ENBRIDGE GAS INC.

First Tracks Consulting Service In. Answers to Interrogatories from School Energy Coalition (OEB)

Exhibit I.7.EGI.SEC.1

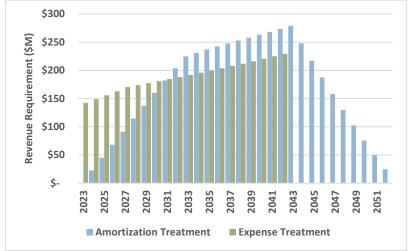
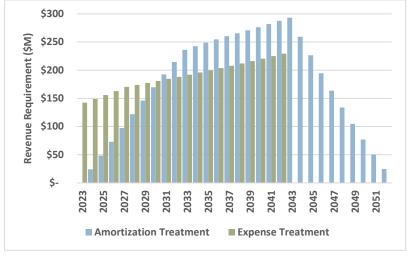
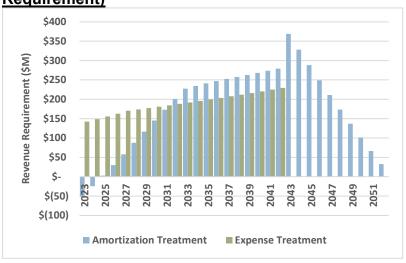
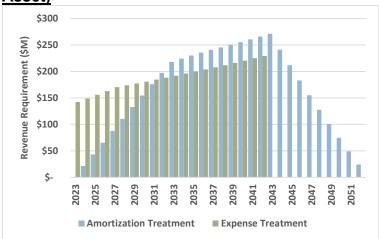
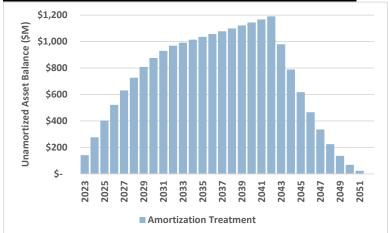
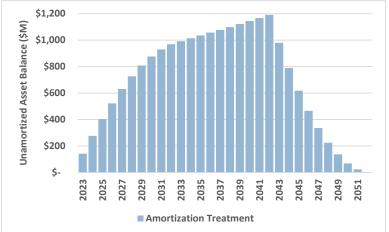
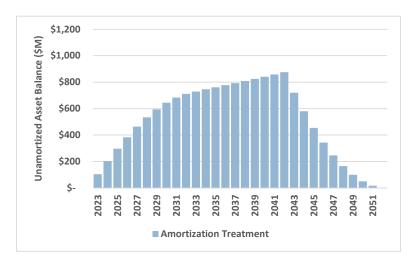
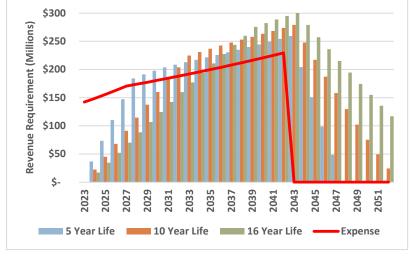
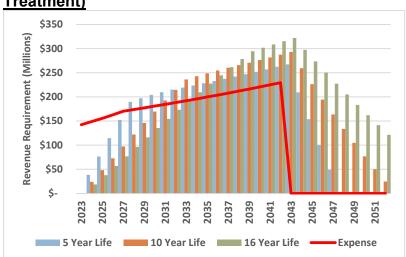
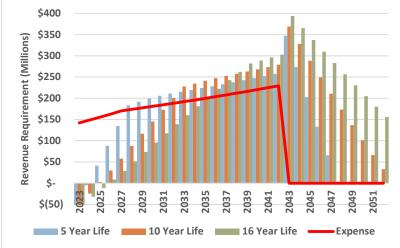
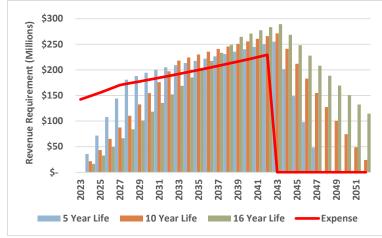
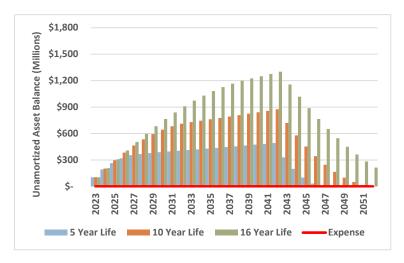
[Ex. Reply, p. 12] Please re-do Figures 3 to 6 taking into account the tax impacts, and provide a live Excel version of the results.

Three versions of Figures 3, 4, 5 and 6, which present revenue requirements, are provided below:

- Figure 3A-6A: original figures from my report, with no tax treatment in revenue requirement
- Figure 3B-6B: Including equity earnings grossed up for income taxes, and amortizing DSM expenditures for tax purposes

- Figure 3C-6C: Including equity earnings grossed up for income taxes, treating DSM expenditures as expenses for tax purposes; and applying the tax benefit as a decrement to revenue requirement in year 1
- Figure 3D-6D: Including equity earnings grossed up for income taxes; treating DSM expenditures as expenses for tax purposes; and applying the tax benefit as a decrement to the size of the regulatory asset funded by Enbridge investors in year 1
